Addendum #	02	Date Issued	03/31/2025
Project Name Job #	SWN 0509, Waneta Hall Renovate Restrooms	OSE # R0325--15X	EAPC #20256780
Bid Date Time	April 3, 2025		3:30pm

THIS ADDENDUM AMENDS AND BECOMES PART OF THE CONTRACT DOCUMENTS FOR EAPC PROJECT 20246780 DATED 03/13/2025, RESPECTIVELY. EACH BIDDER SHALL ACKNOWLEDGE RECEIPT OF THIS ADDENDUM BY MARKING THE ADDENDUM NUMBER AND DATE ON THE BID FORM.

DRAWING TITLE
FINISH PLAN - FIRST FLOOR

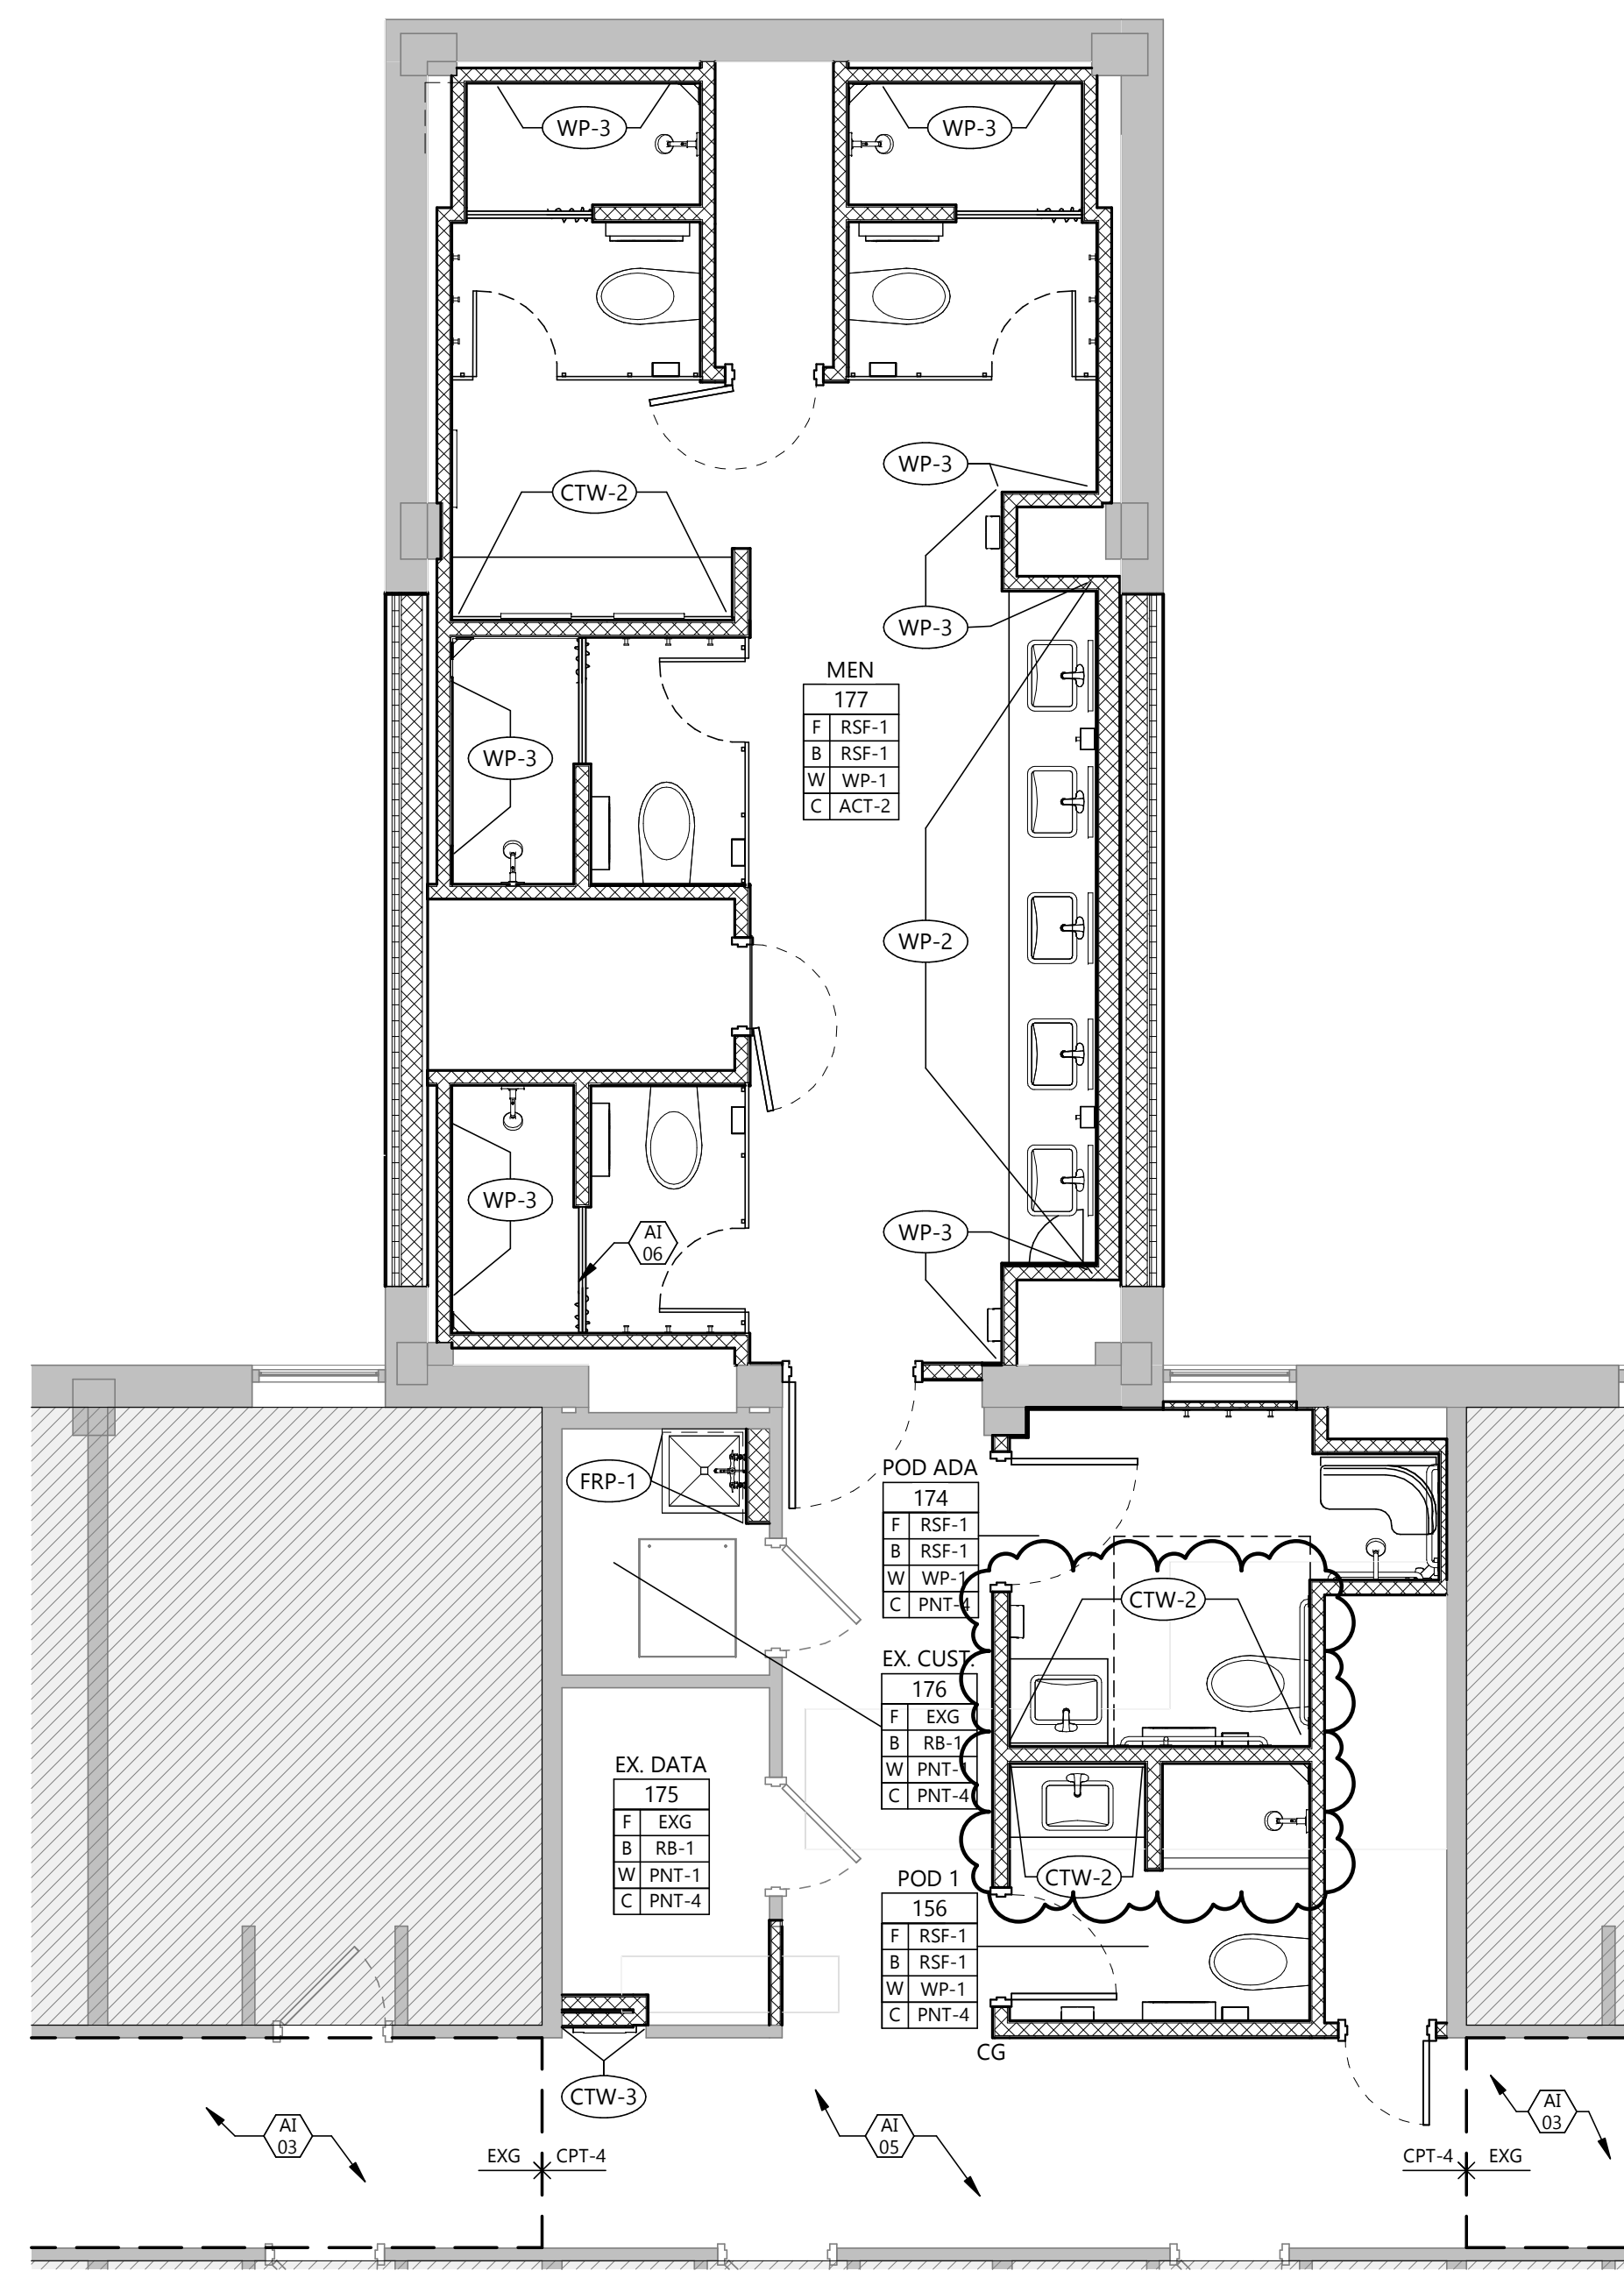
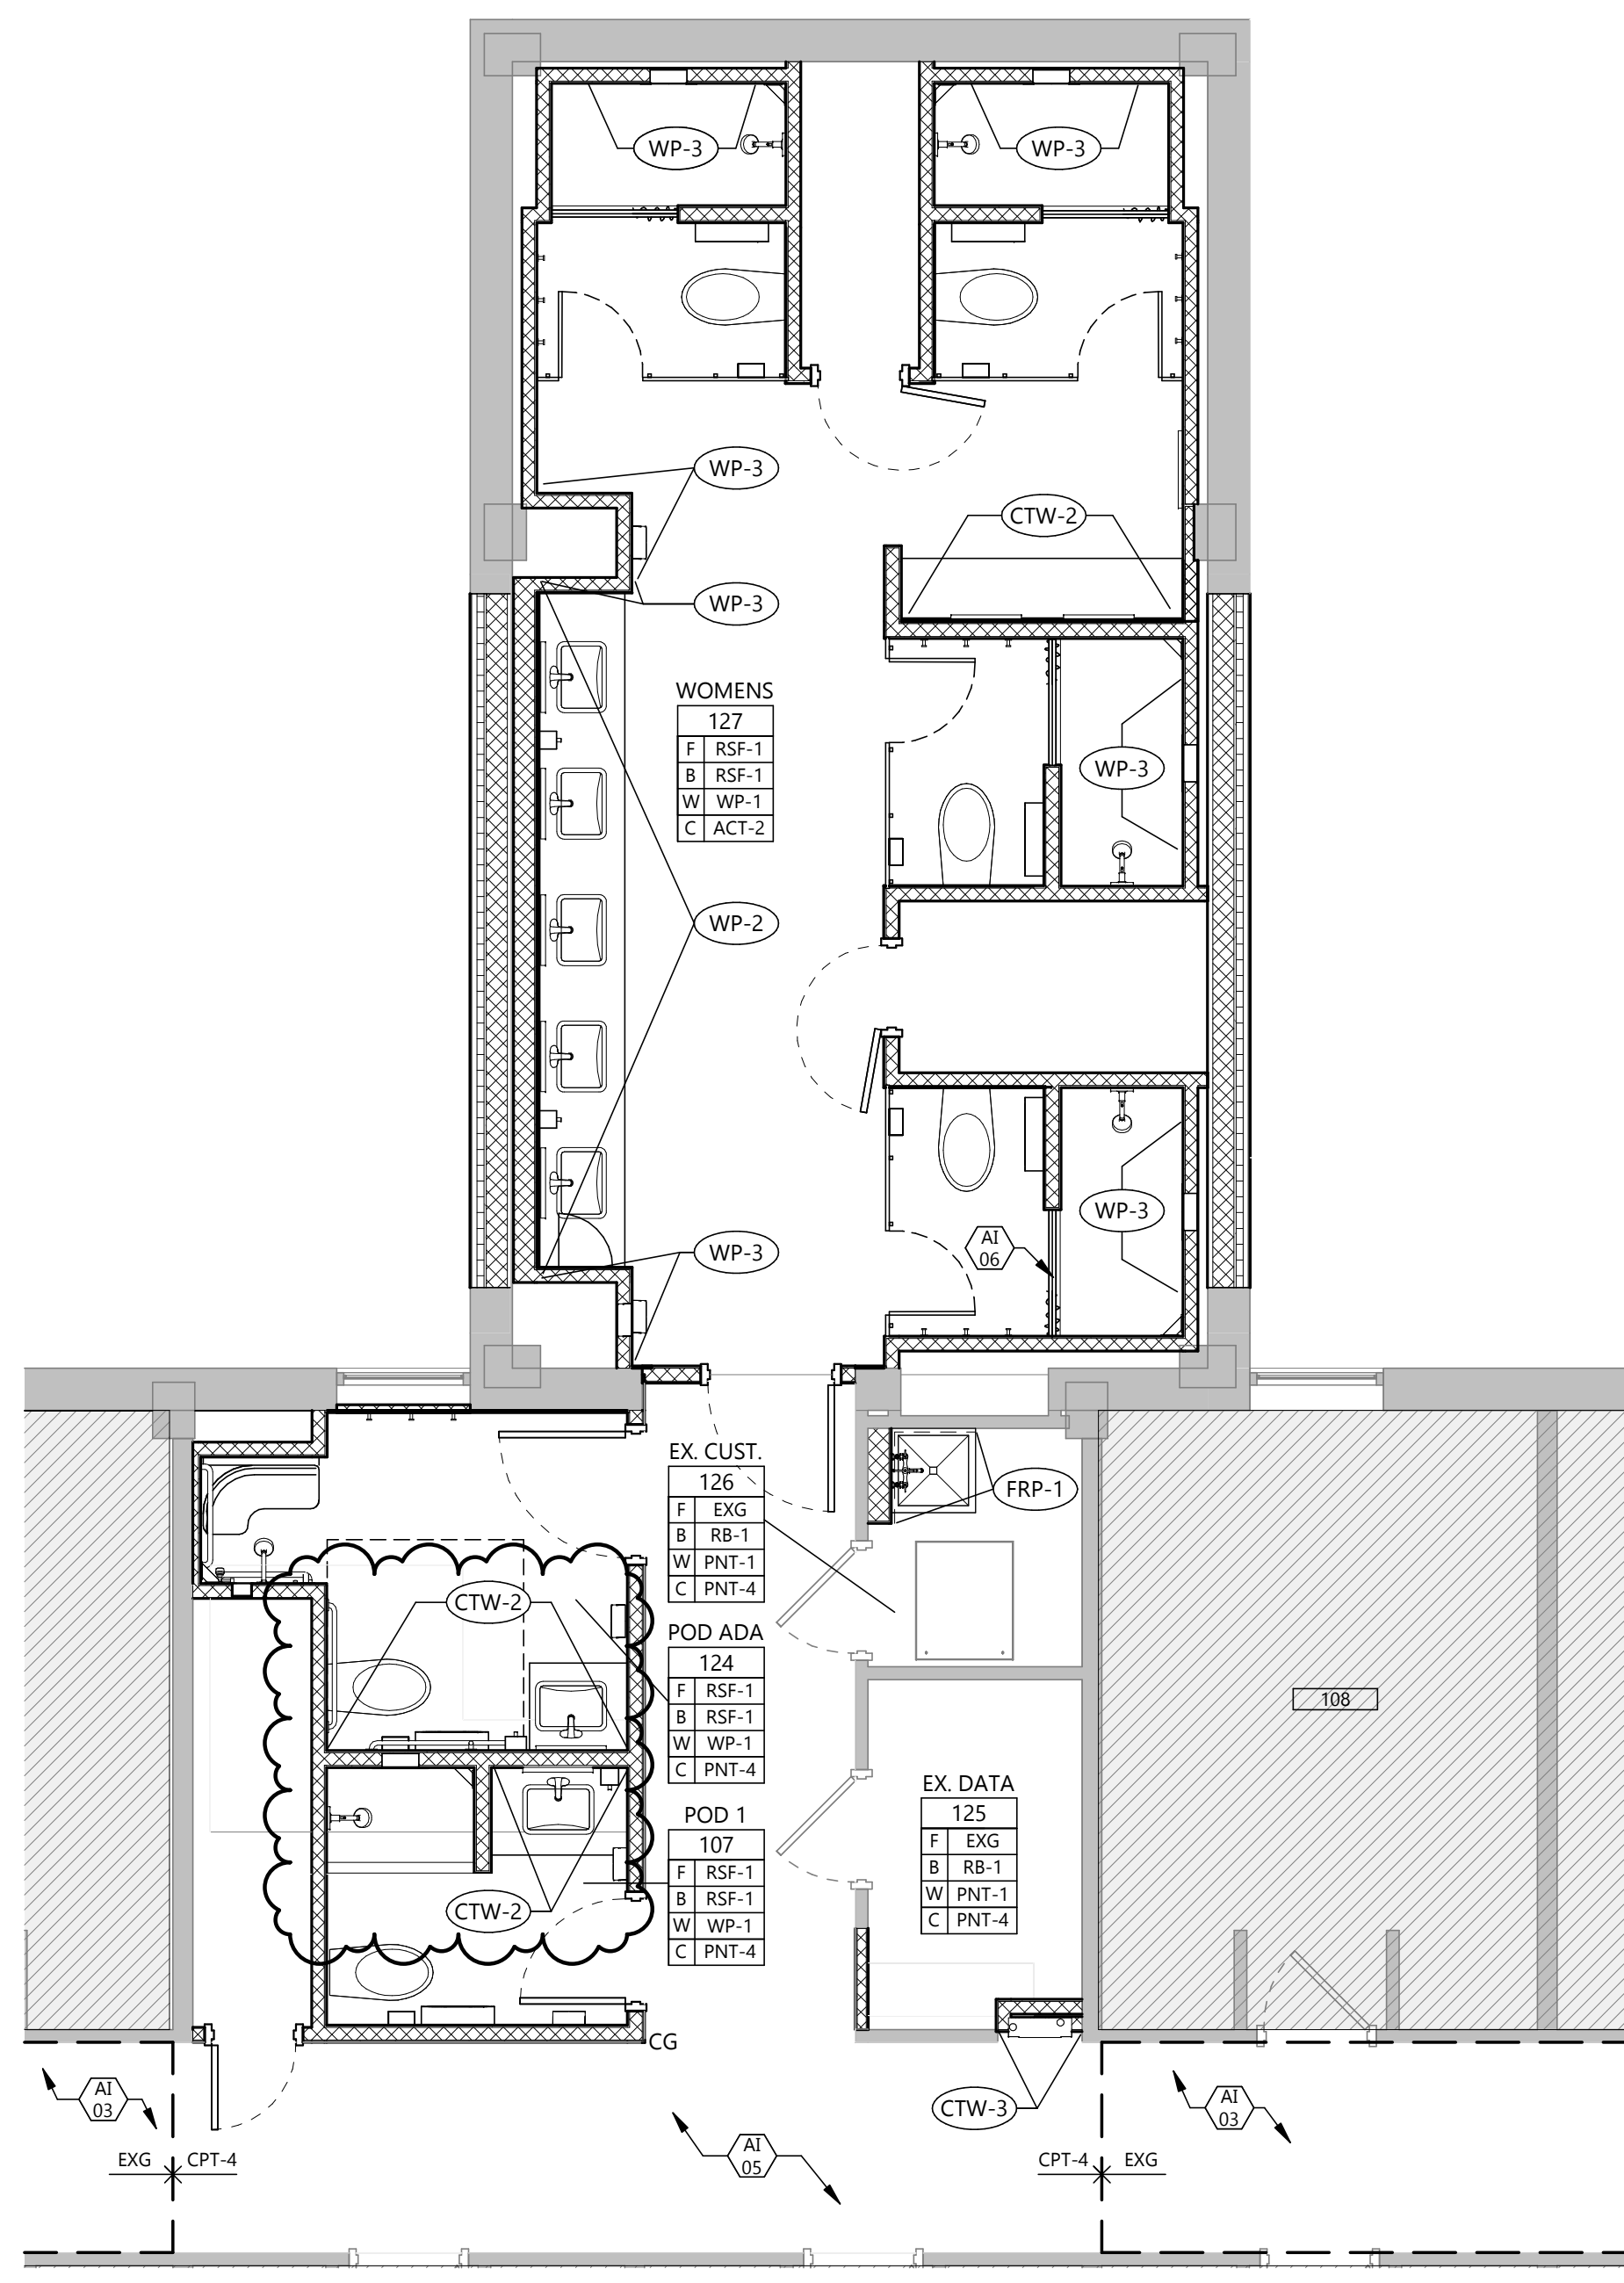
- A702 REVERSE tile extents at 7/A702.
- A901 REVERSE Keynote AI 03.
REVERSE CTW-1 to CTW-2.
CLARIFY paint finishes at General Finish Notes 5,17,19, and 22.
